ADDENDUM NO. 8 TO PROJECT NO. 44578

CONSTRUCTION WORK - PLA
MAJOR BUILDING RENOVATIONS FOR THE
MANHATTAN FORENSIC
RELOCATION
MANHATTAN PSYCHIATRIC CENTER
600 EAST 125th STREET
WARDS ISLAND, NY 10035

September 29, 2015

THIRD FLOOR DEMOLITION AND WINDOW INSTALLATION PLAN

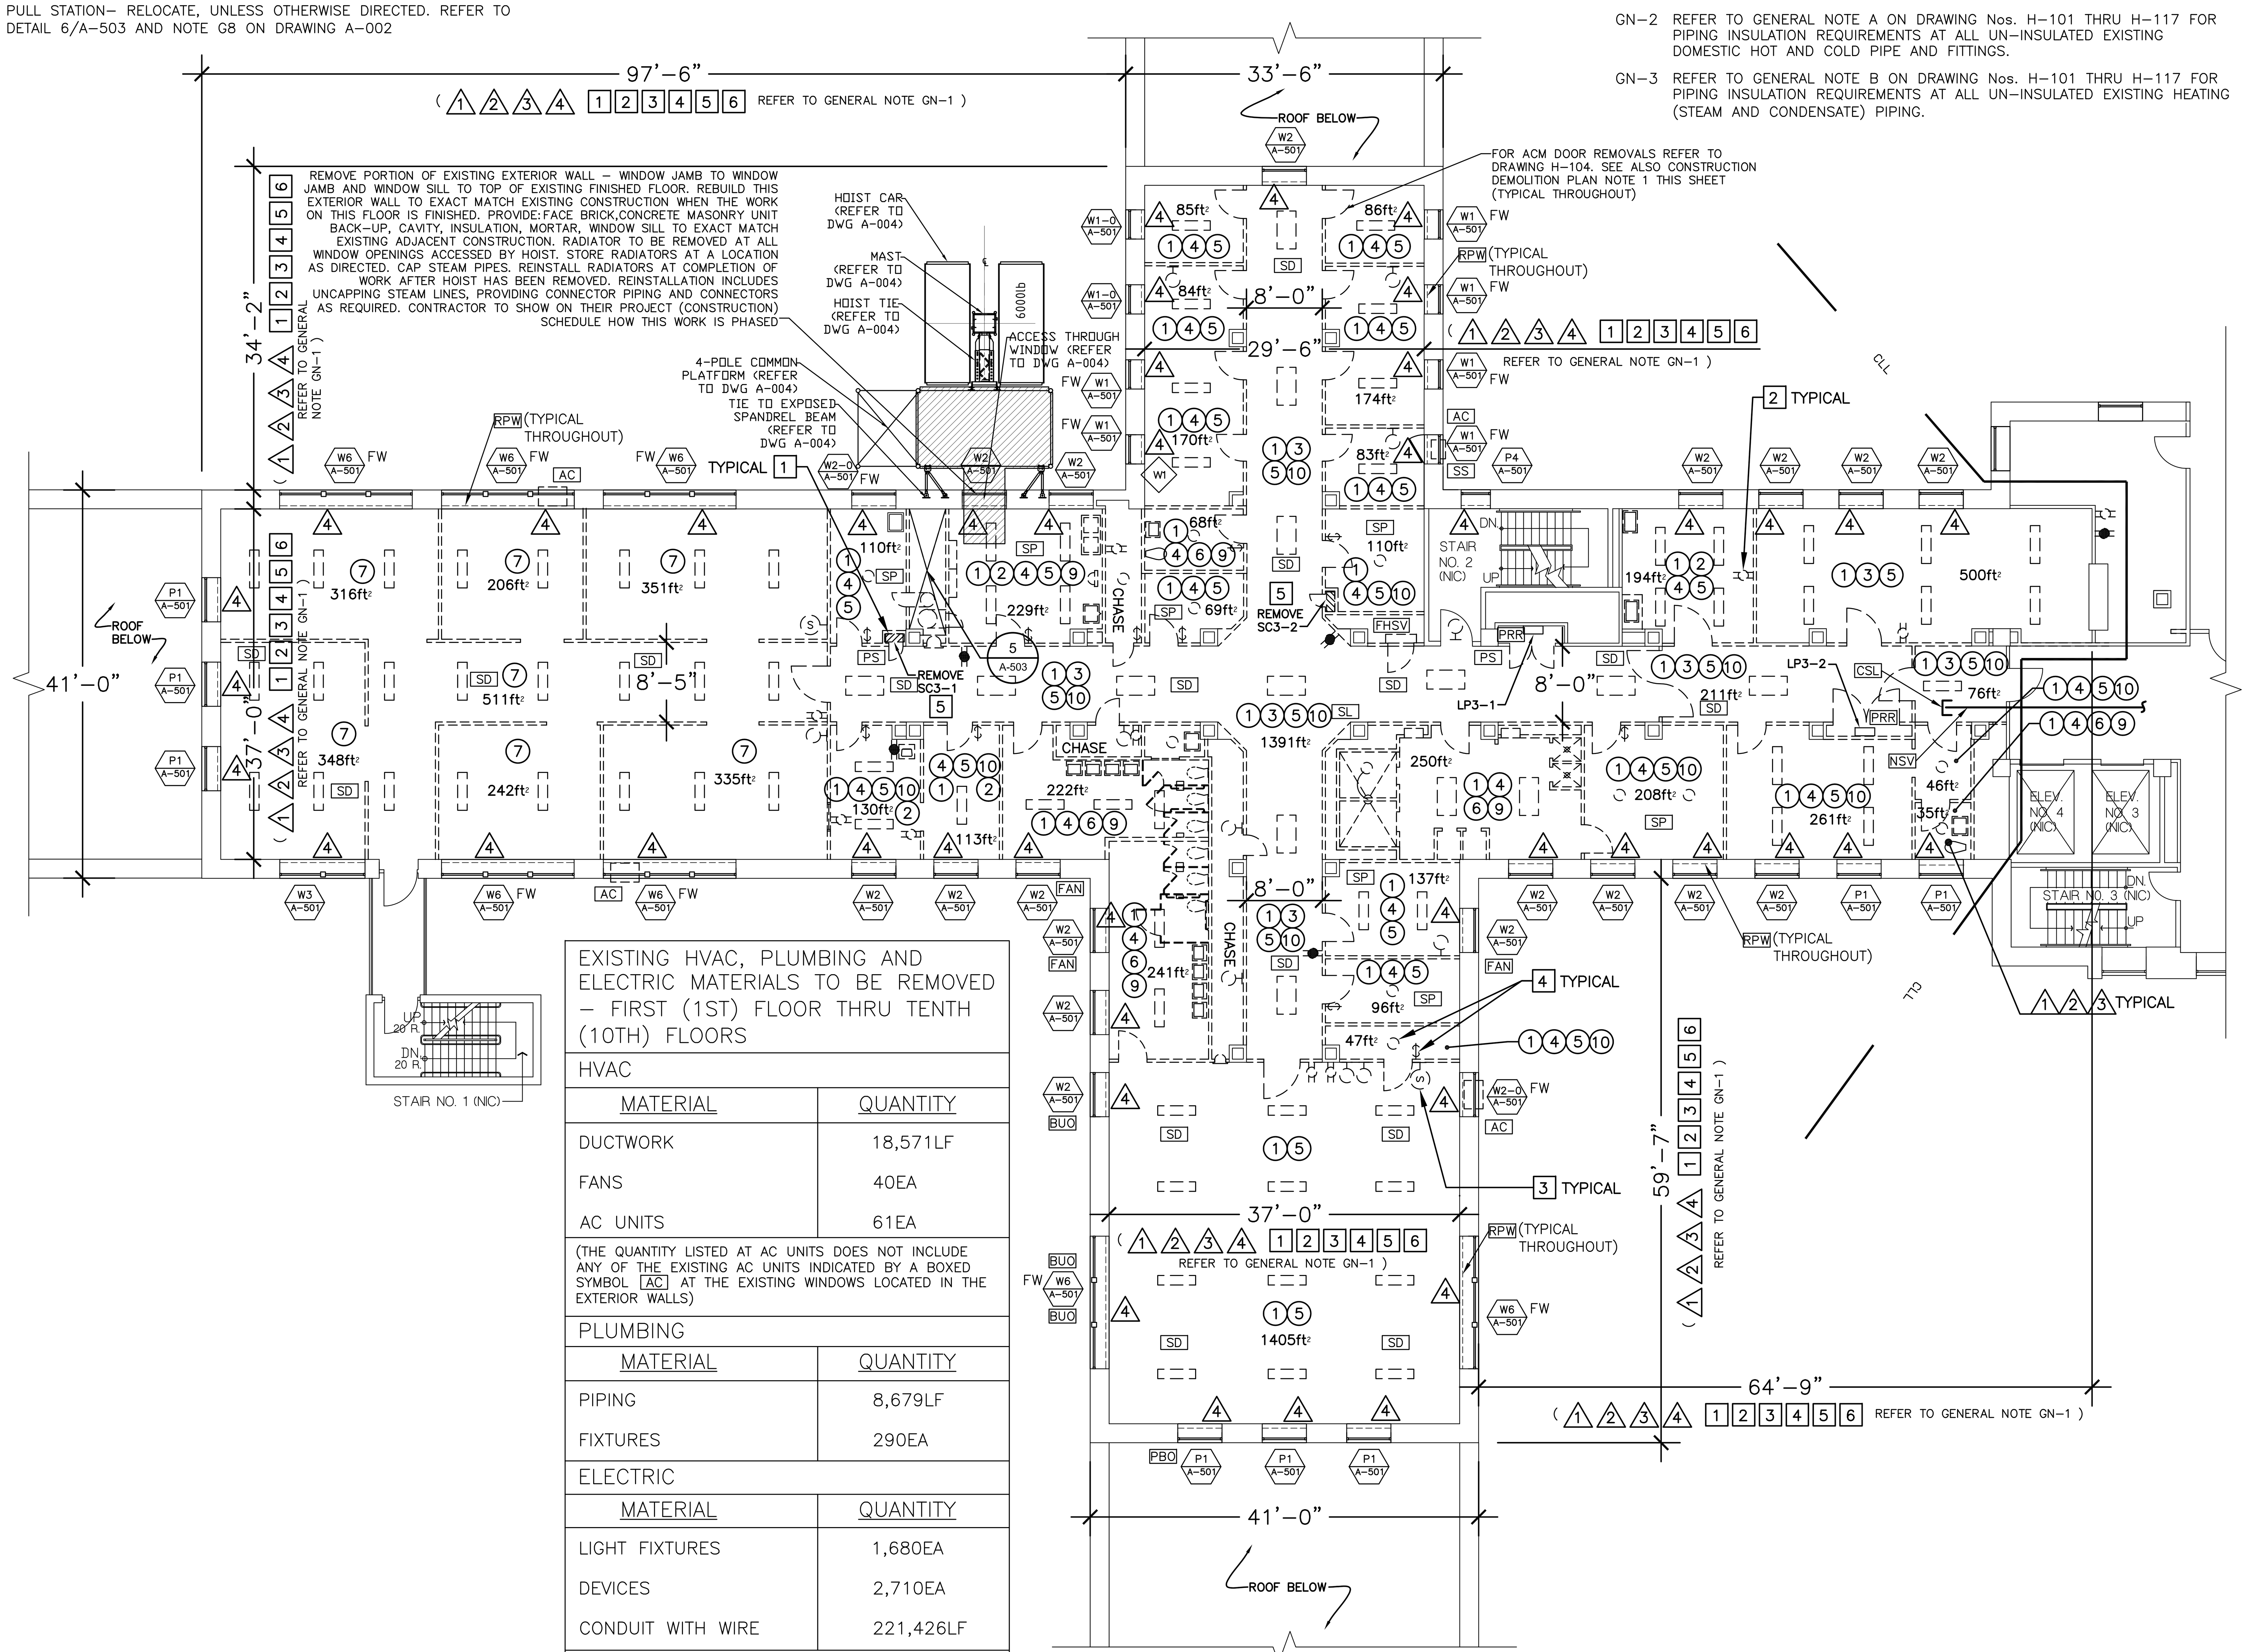
34. Revised Drawing (issued with Addendum #5) No. Drawing No. A-102-2C: At column line 11& H, add type “J” divider wall to mechanical shaft as shown on Dwg. A-102-2C.

FOURTH FLOOR DEMOLITION AND WINDOW INSTALLATION PLAN

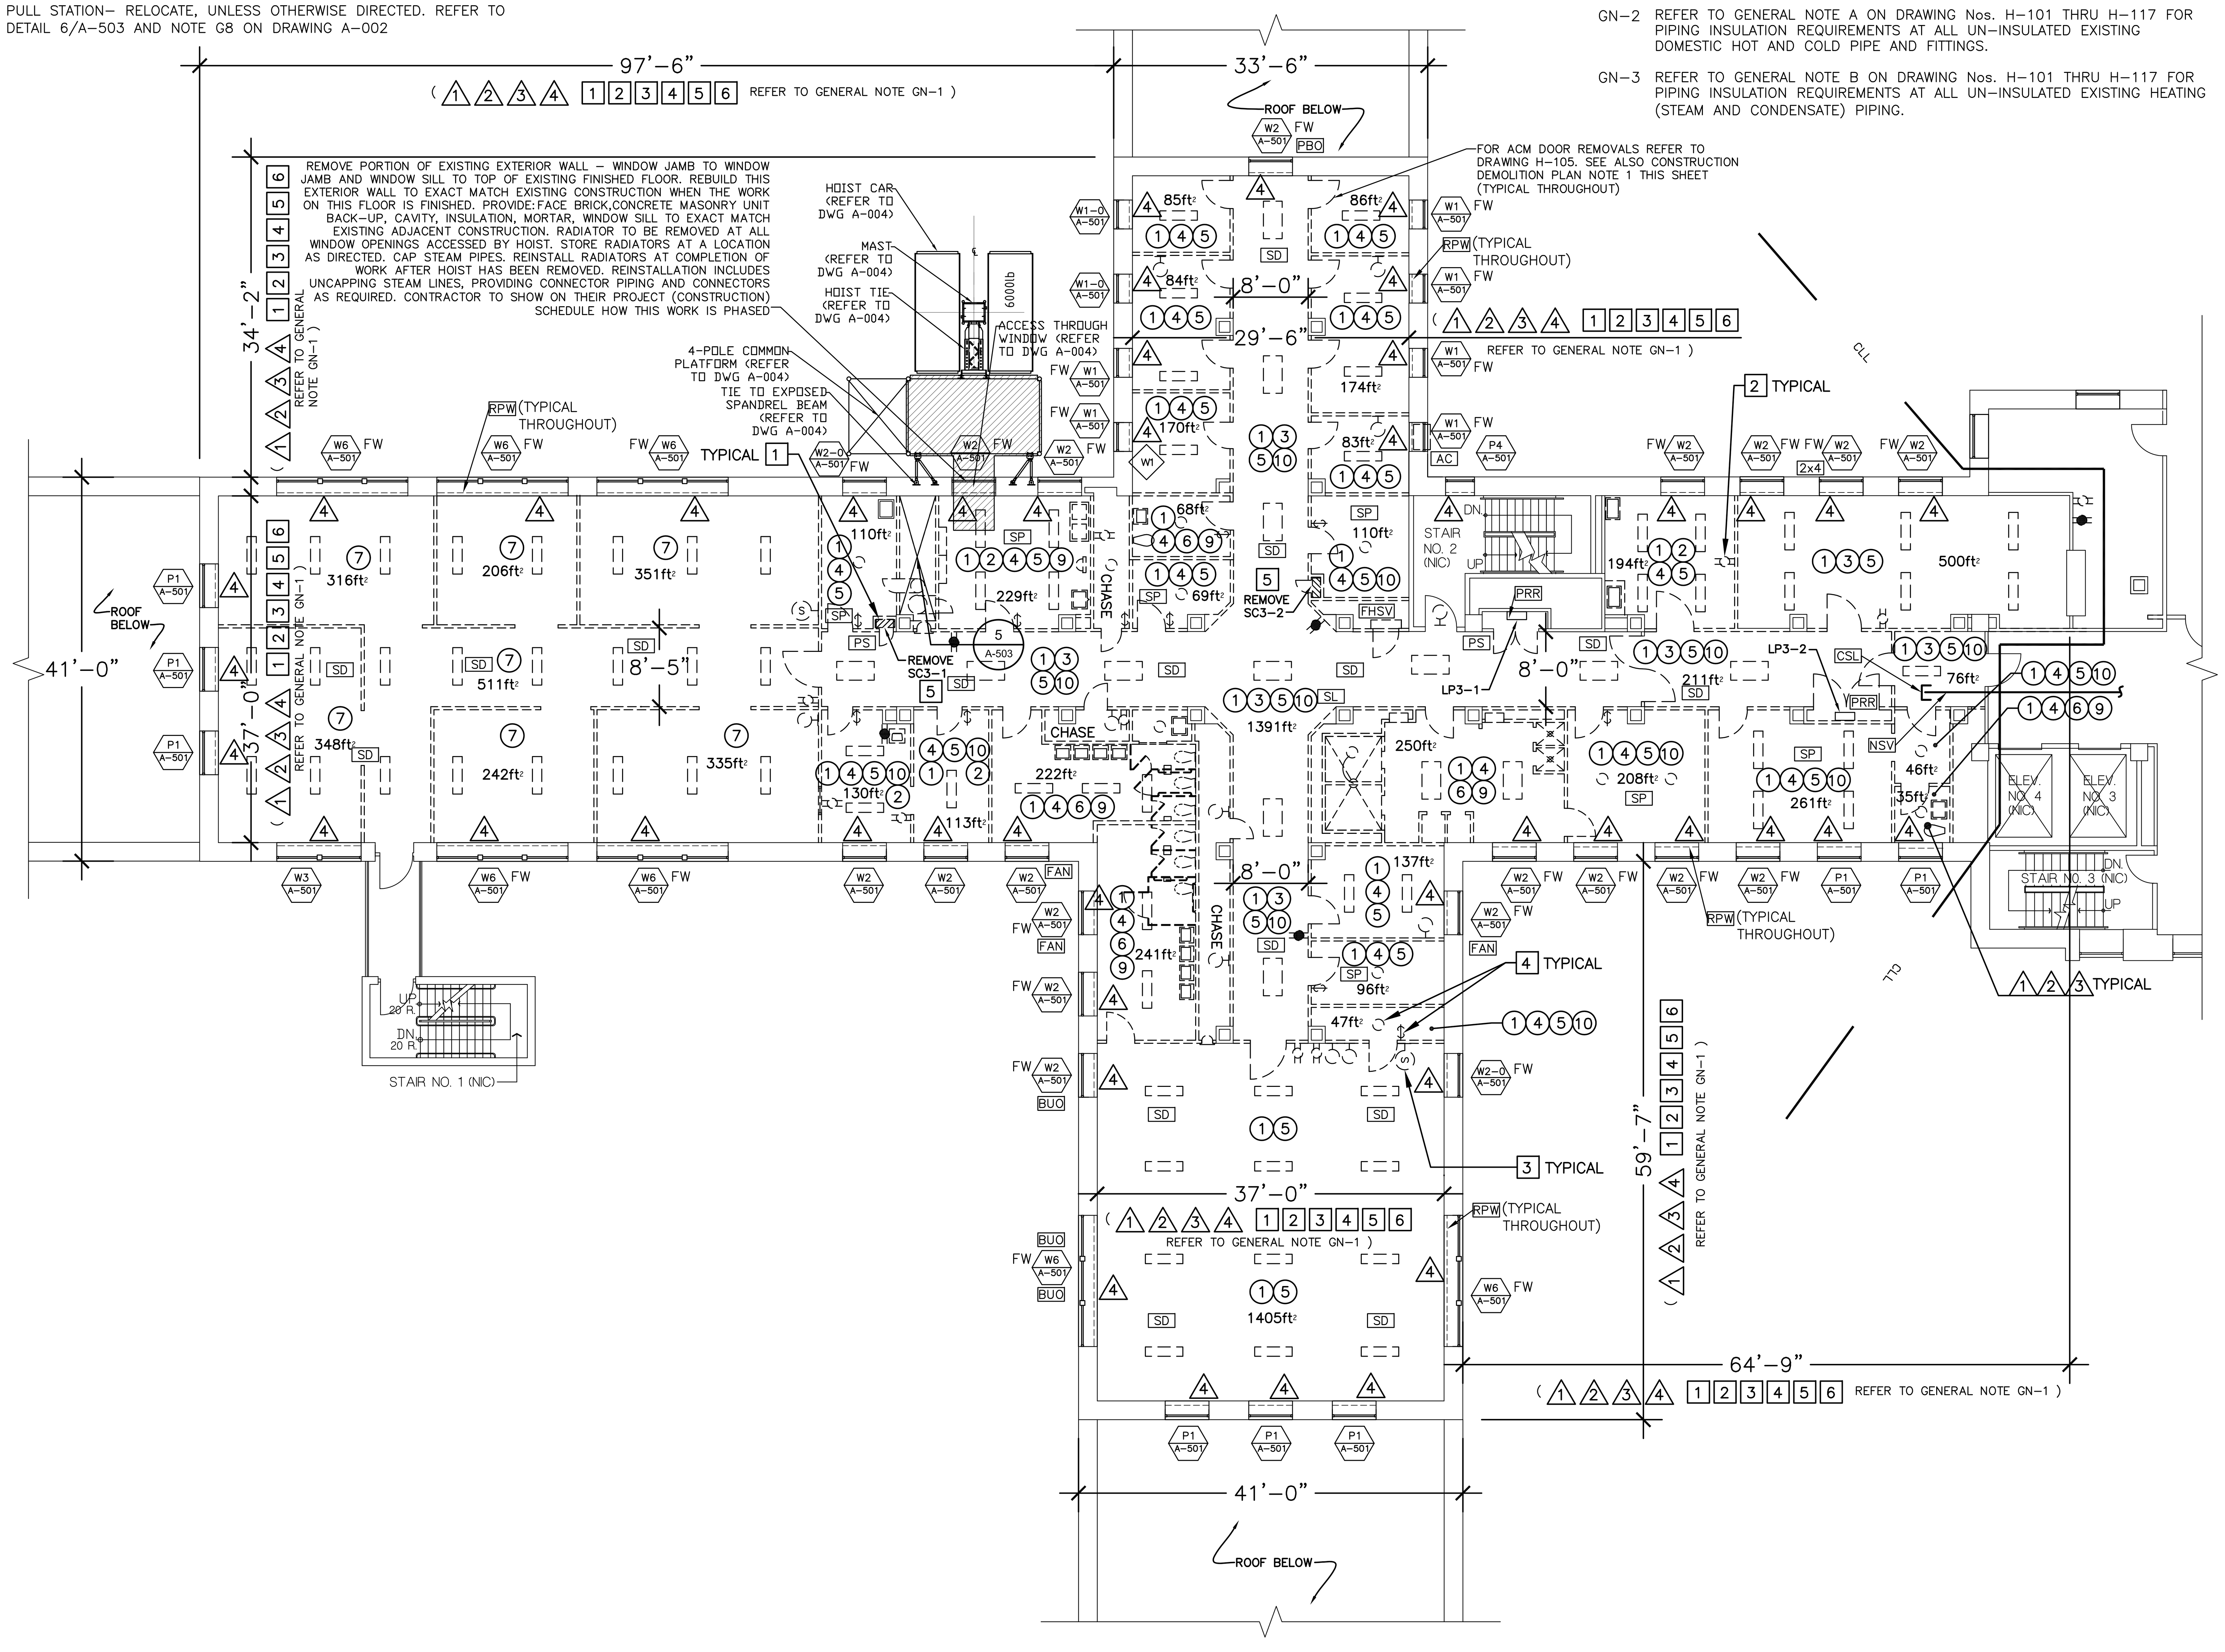
39. Drawing No. A-104-2:
    a. Revise Room names for 434A and 447A from “Passage“ to “Secure Corridor”.
    b. Delete detail tag 8/504-2 at column line H between 1 and 2, at column line 10 between N and O, at column line 1 and K, and at column line 6 between M and N.

FIFTH FLOOR DEMOLITION AND WINDOW INSTALLATION PLAN
3/32" = 1'-0"

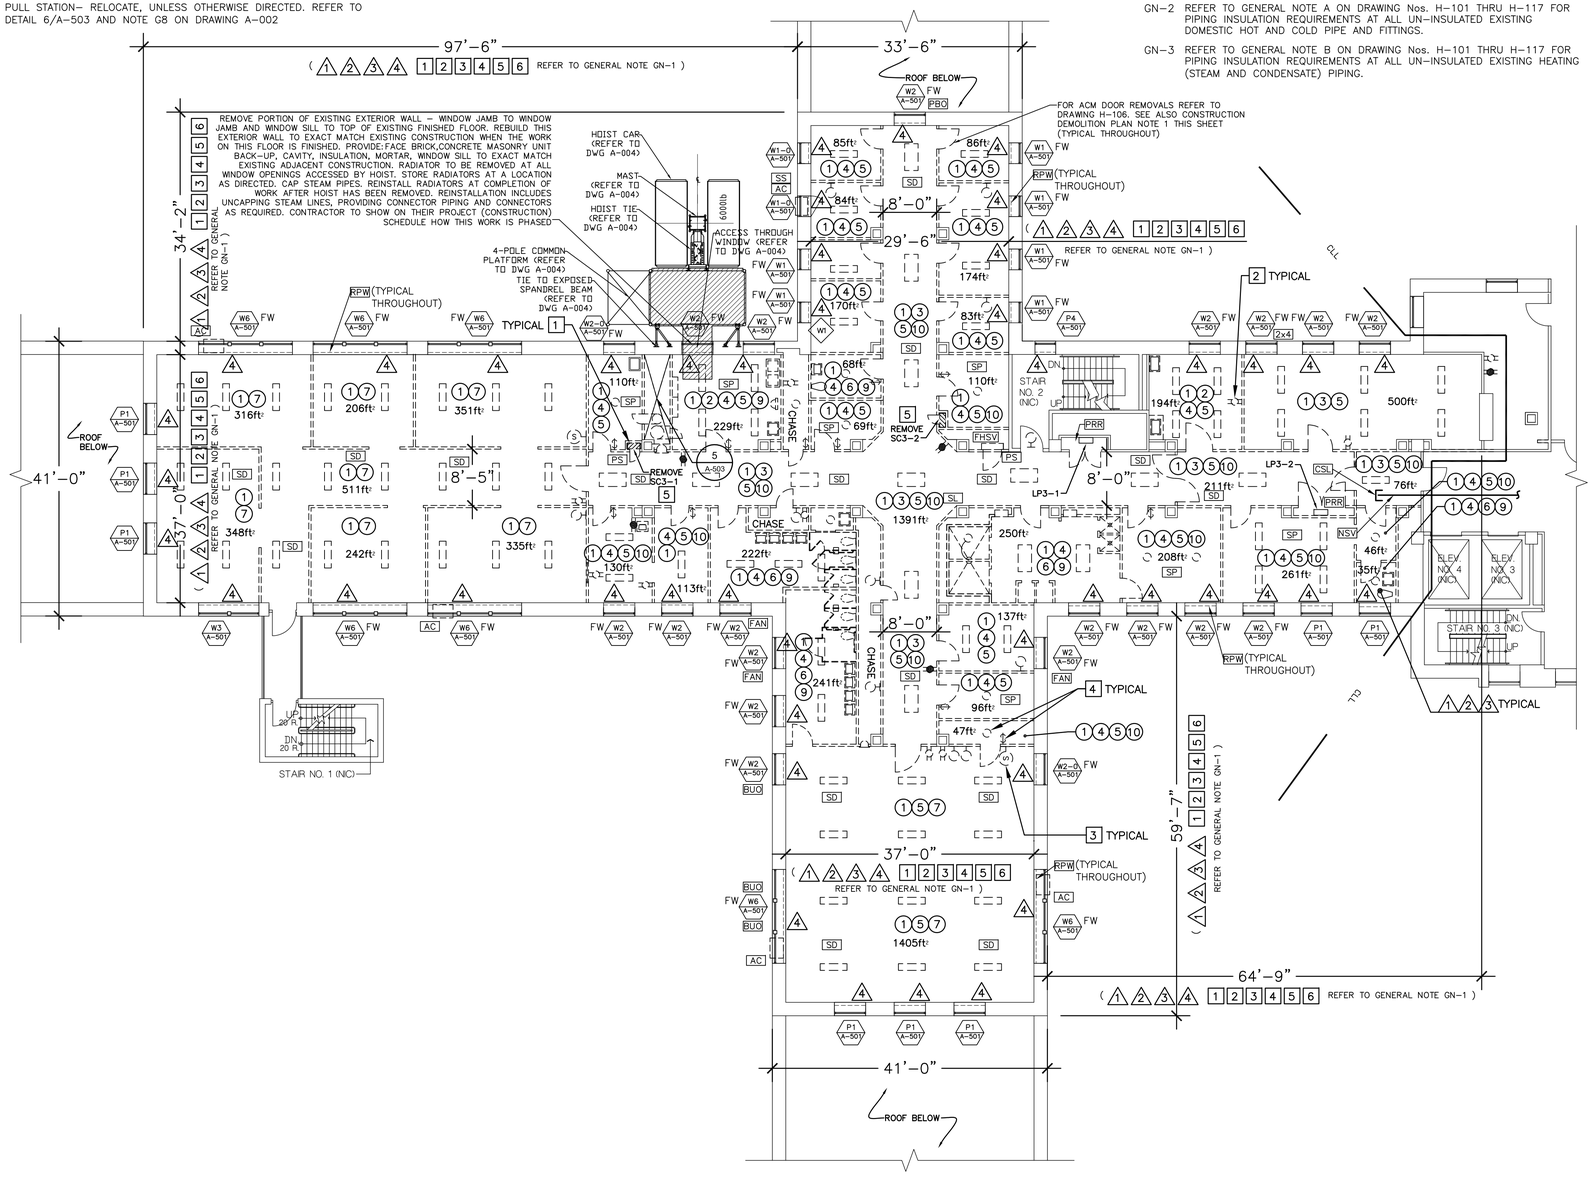
40. Revised Drawing (issued with Addendum #5) No A-105-2:
    a. Revise Room names for 534A and 547A from “Passage“ to “Secure Corridor”.
    b. Delete detail tag 8/504-2 at column line H between 1 and 2, at column line 10 between N and O, and at column line 1 and K.

SIXTH FLOOR DEMOLITION AND WINDOW INSTALLATION PLAN

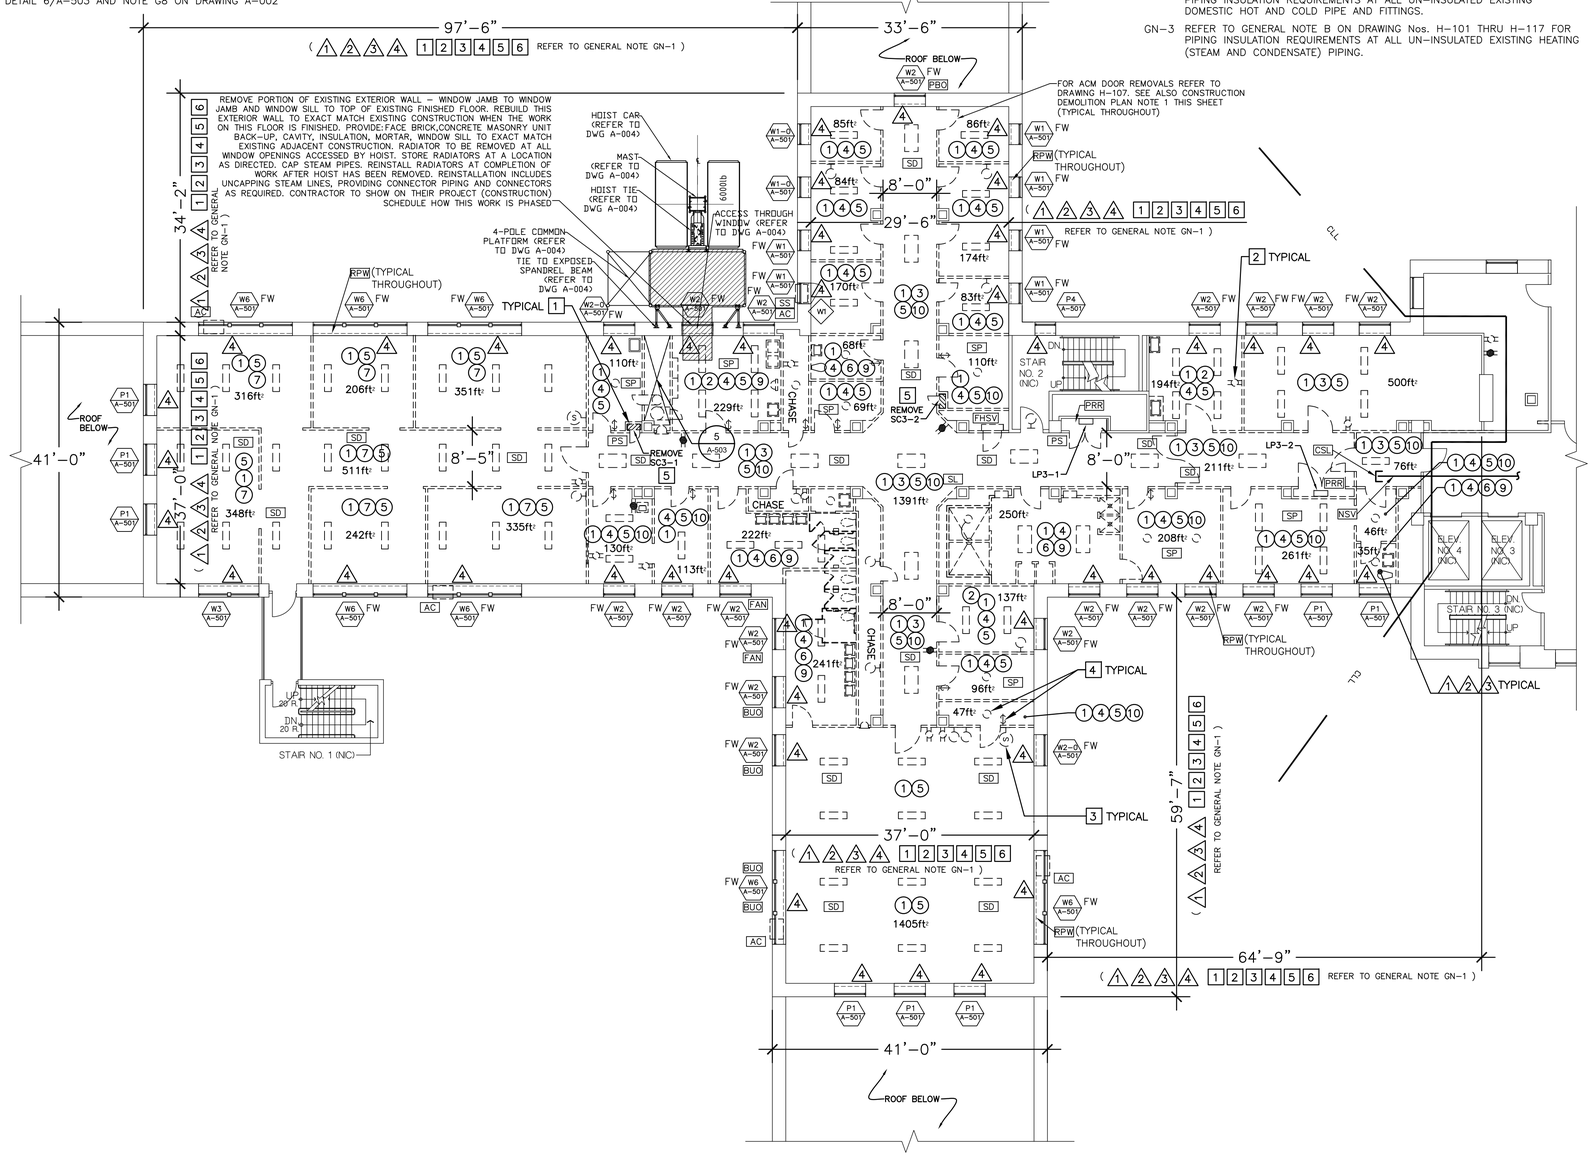
41. Revised Drawing (issued with Addendum #5) No A-106-2:
    a. Revise Room names for 634A and 647A from “Passage“ to “Secure Corridor”.
    b. Delete detail tag 8/504-2 at column line H between 1 and 2, at column line 10 between N and O, and at column line 6 between M and N.
